Board of Adjustments regular meeting

April 20, 2021 at 5:00p.m.

1. Request of Thomas Ladyman, on behalf of Idelisa Torres, for a variance to allow an existing screen enclosure to remain located 9.1 feet from the rear lot line, in lieu of the required rear setback of 10 feet and to allow 169 square feet of screen enclosure beyond the allowable area.

2. Request of Emiel McNish, on behalf of Ketan Pandya, for variances to allow the construction of a boathouse to extend approximately 70 feet into Lake Berry in lieu of the maximum permitted distance of 30 feet and allow an area of 960 square feet, in lieu of the maximum allowed area of 600 square feet.

Proposed Roof Connection

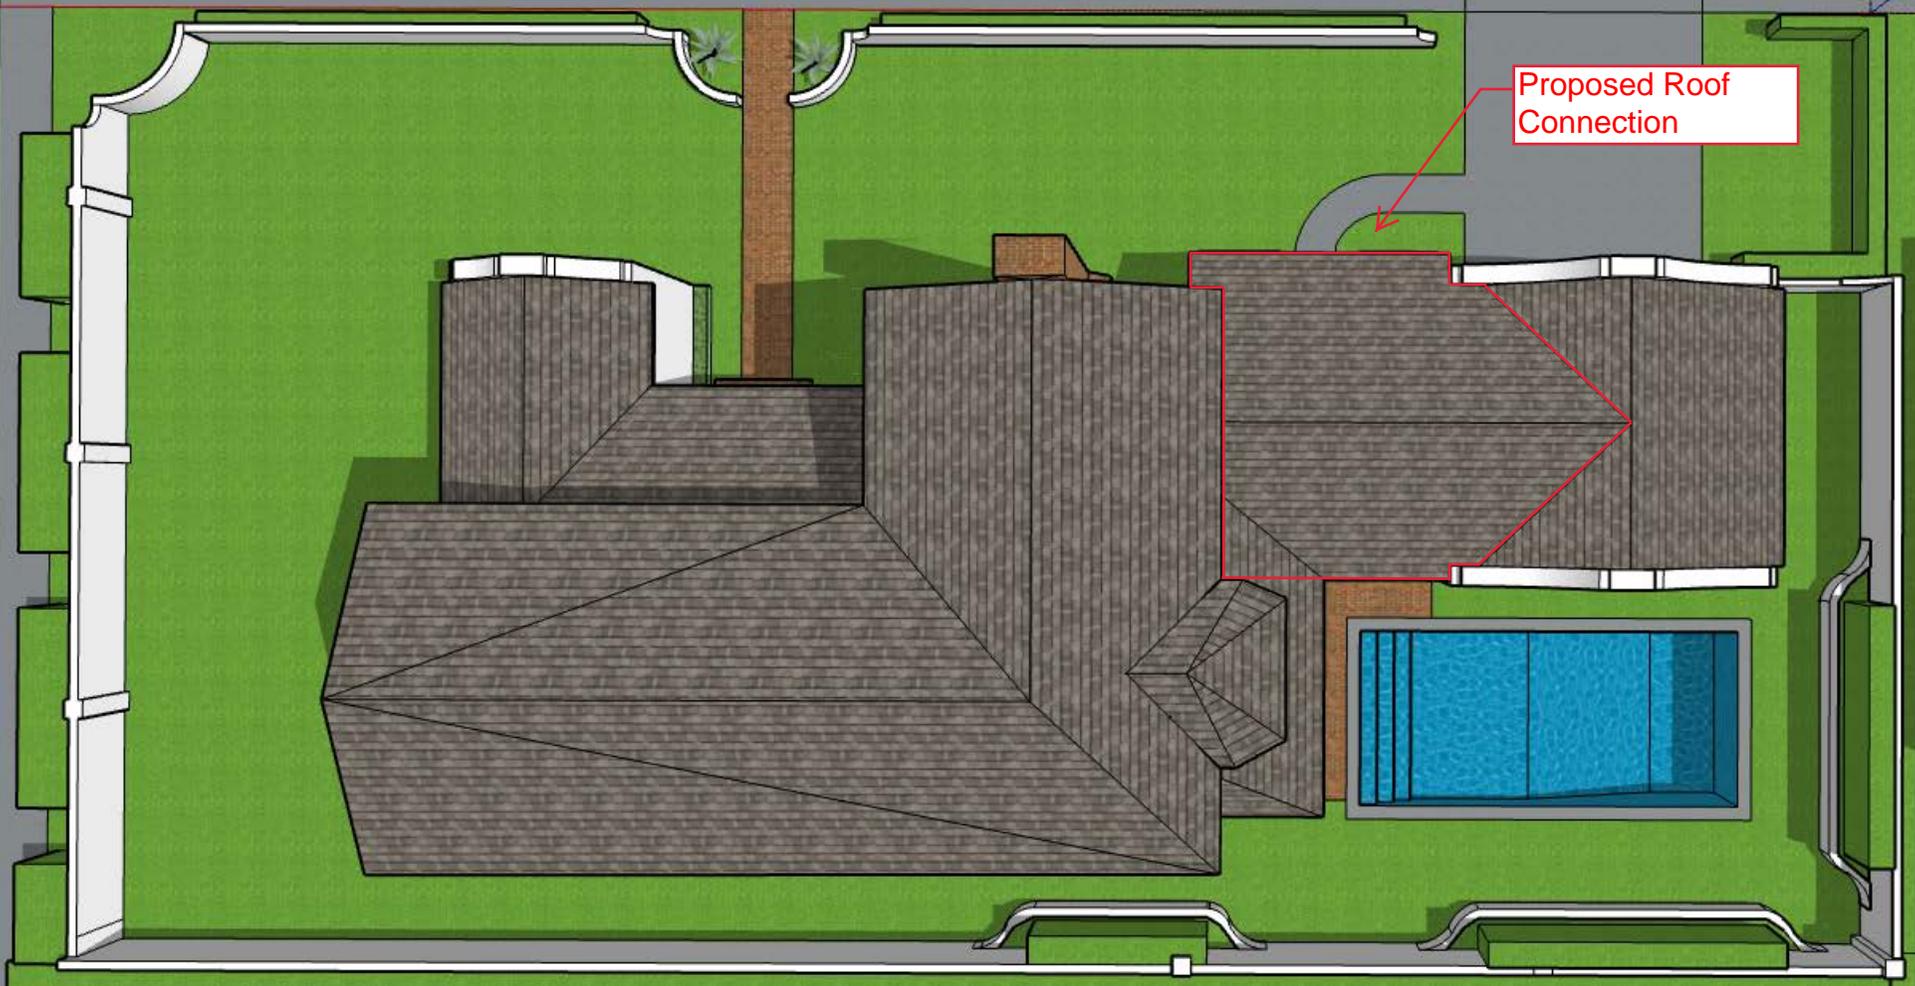
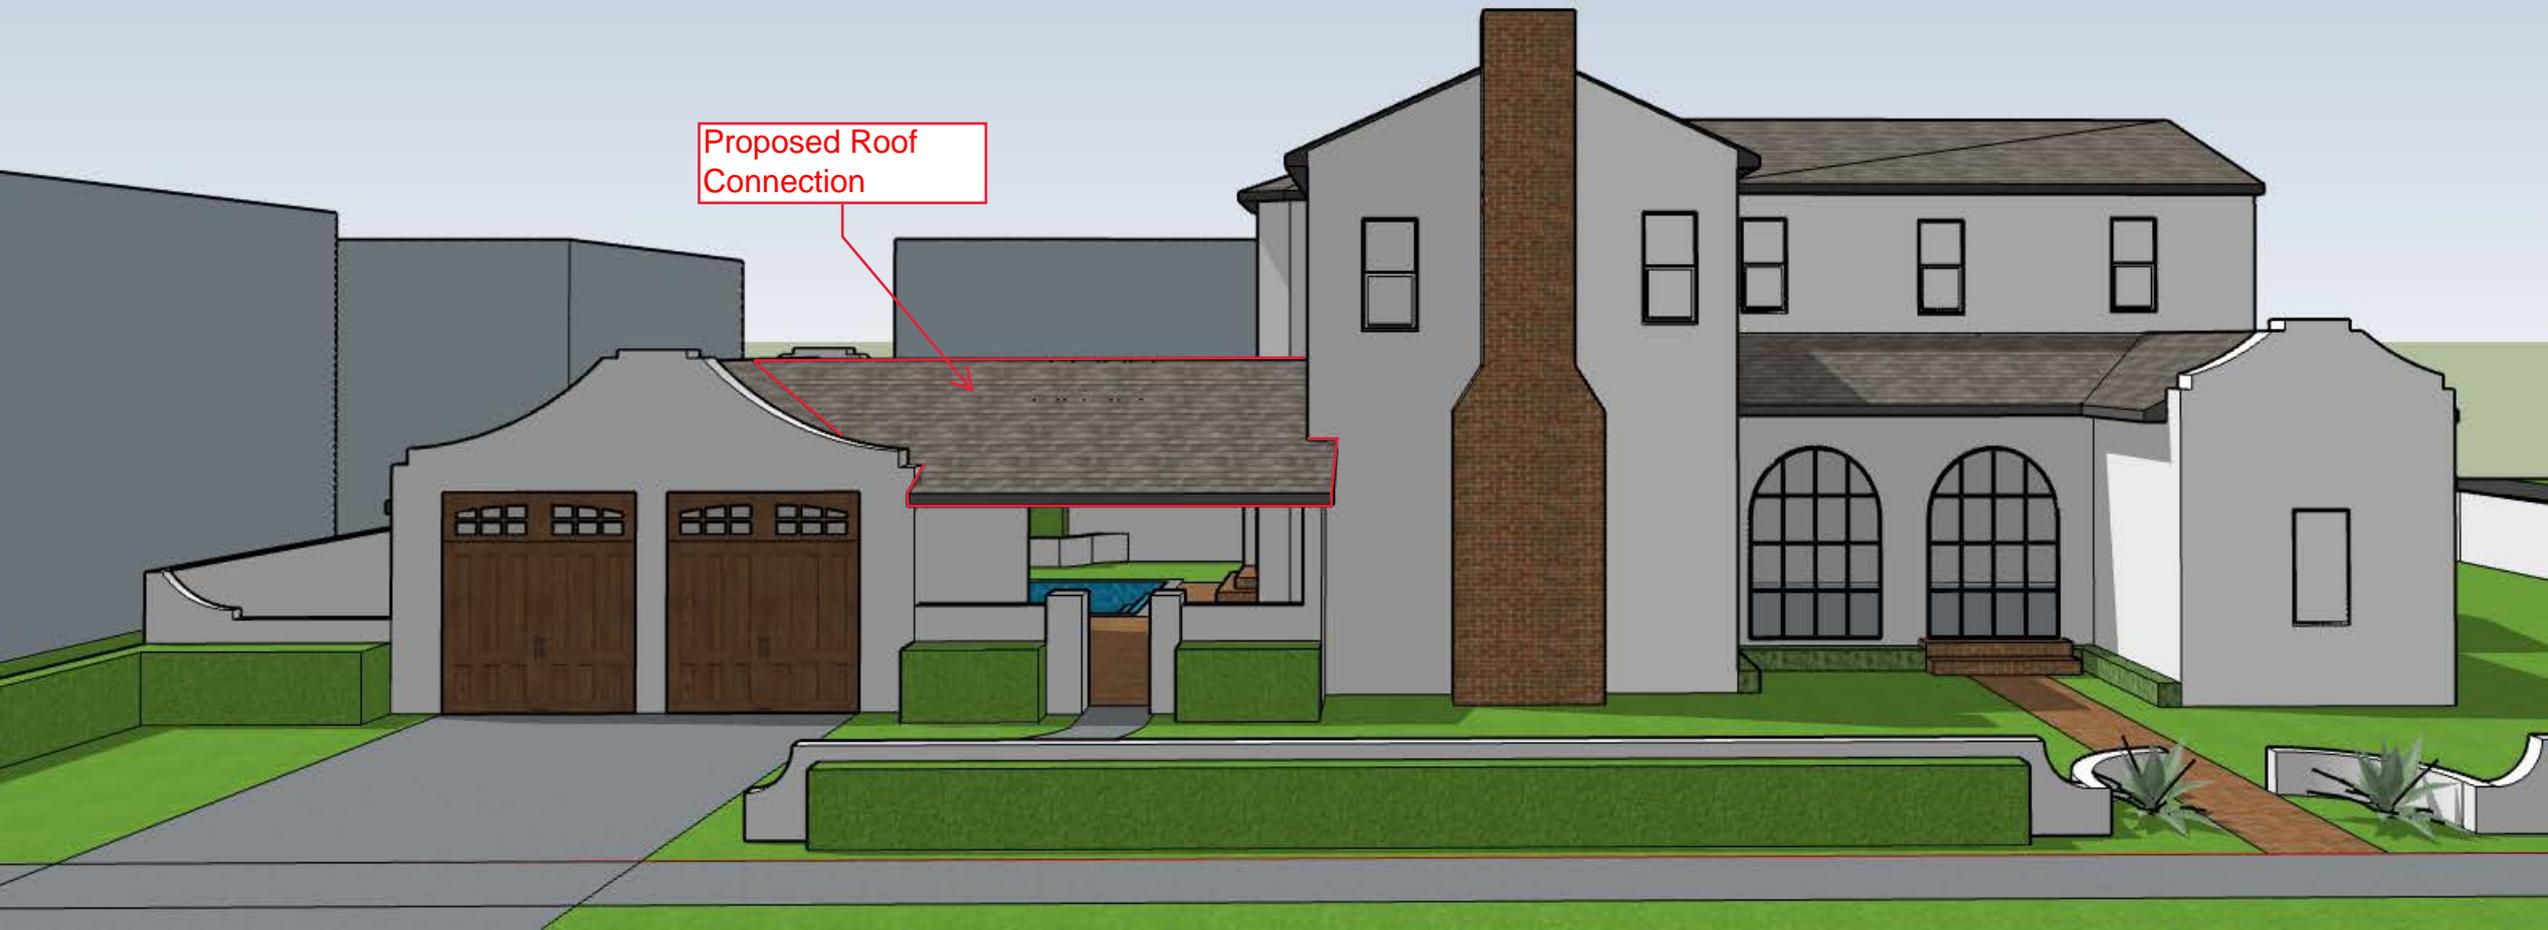
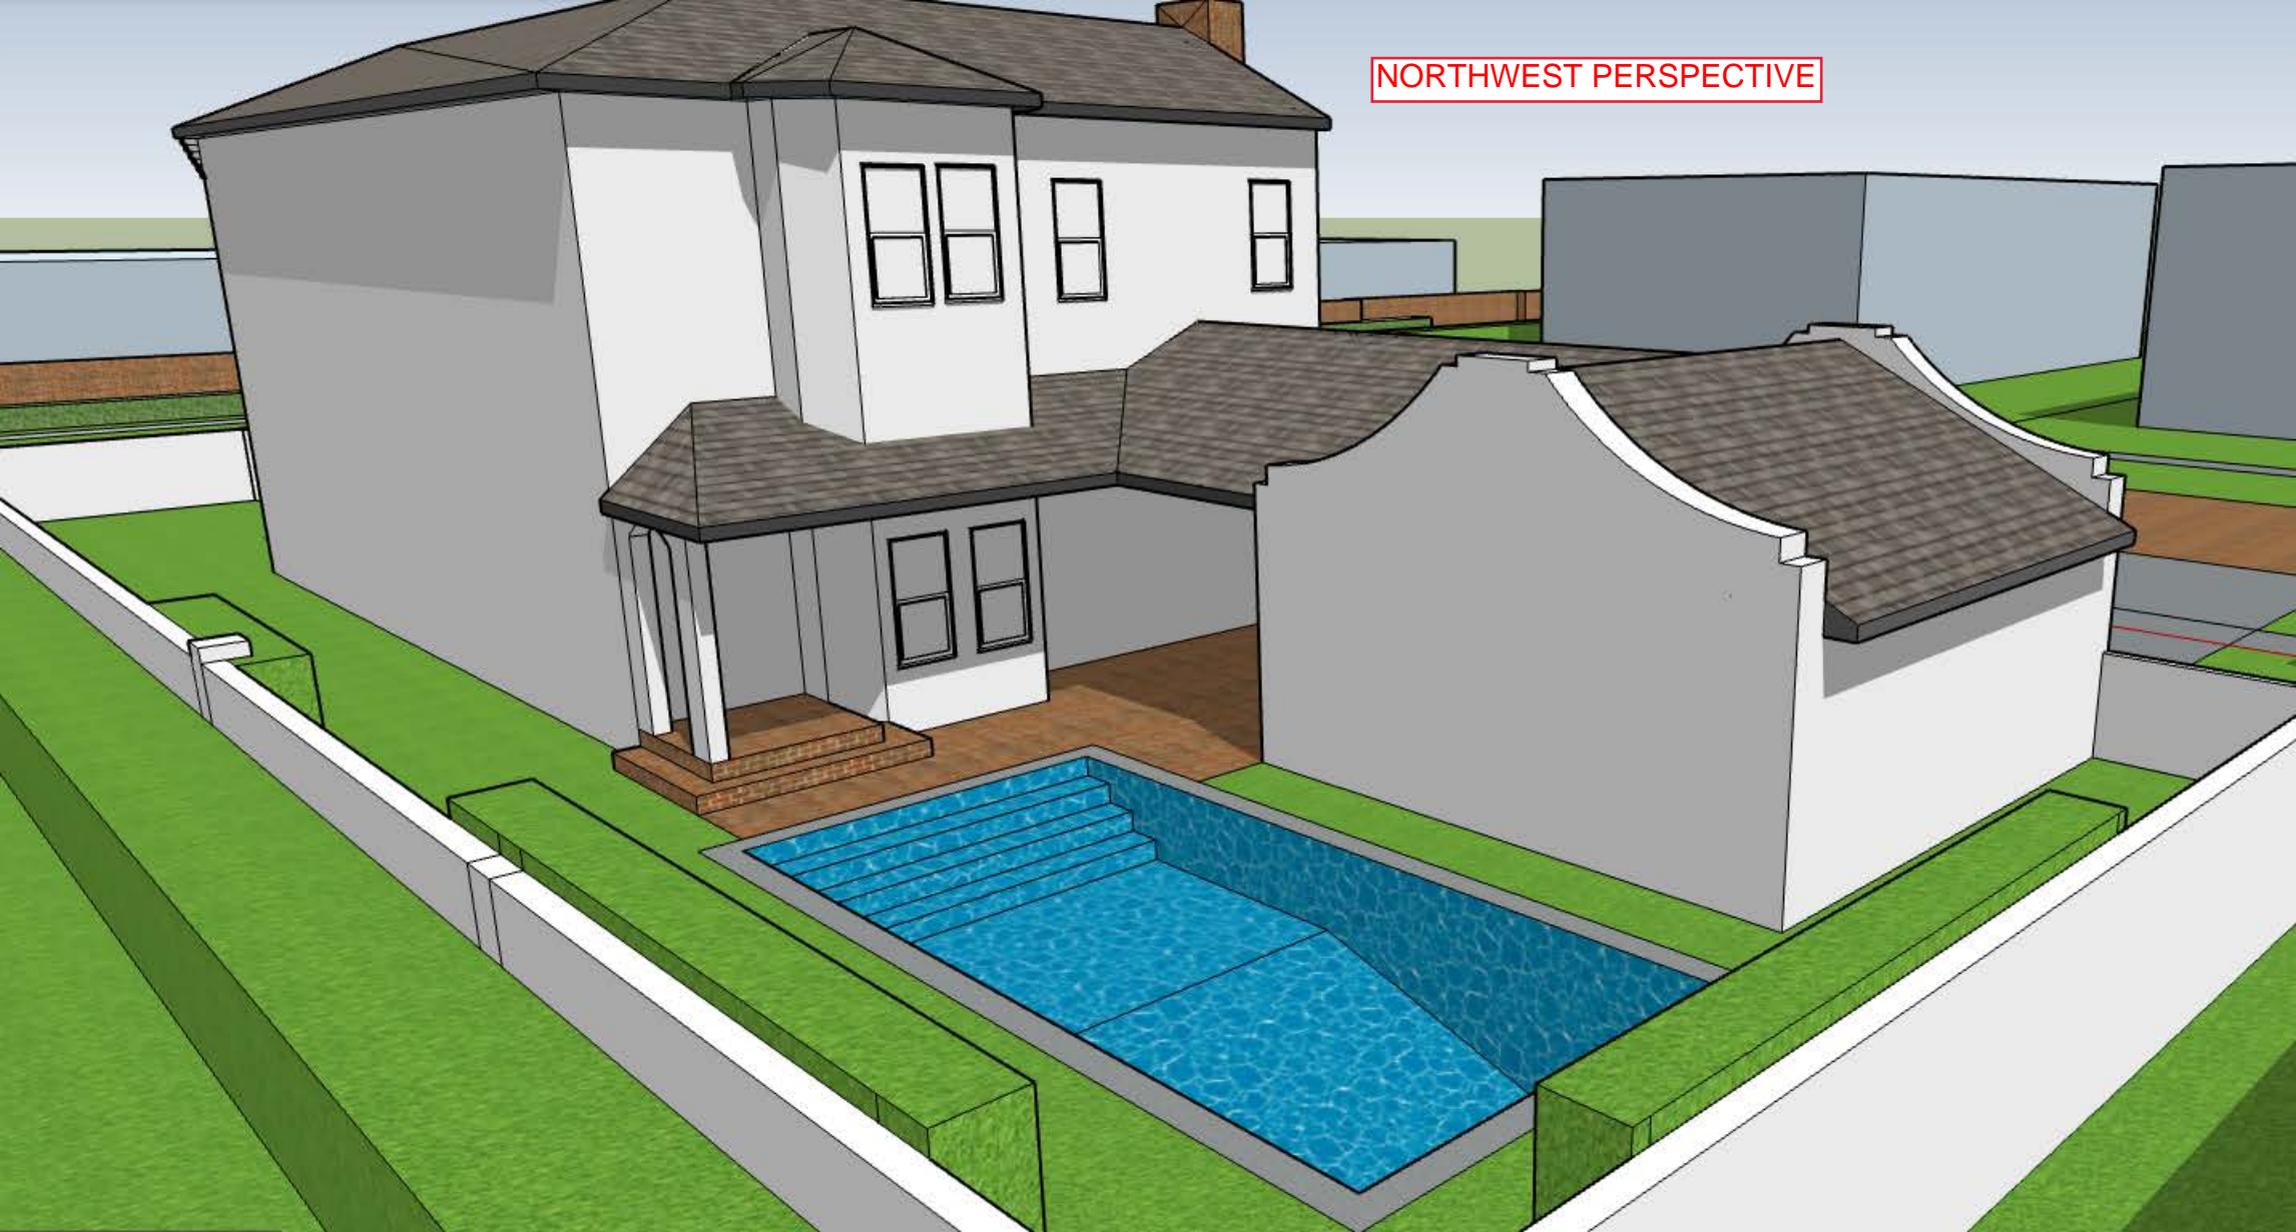
4. Requests of Brad Caldwell for a variance to allow a 5 feet high masonry wall located 5 feet from the front lot line in lieu of the maximum permitted height of 3 feet; and to allow an open roof connection 22 feet wide between the existing home and garage (with an existing rear setback of 10 feet), in lieu of the maximum permitted open walkway width of 8 feet and in lieu of meeting the current rear setback of 25 feet when connecting the garage directly to the home.
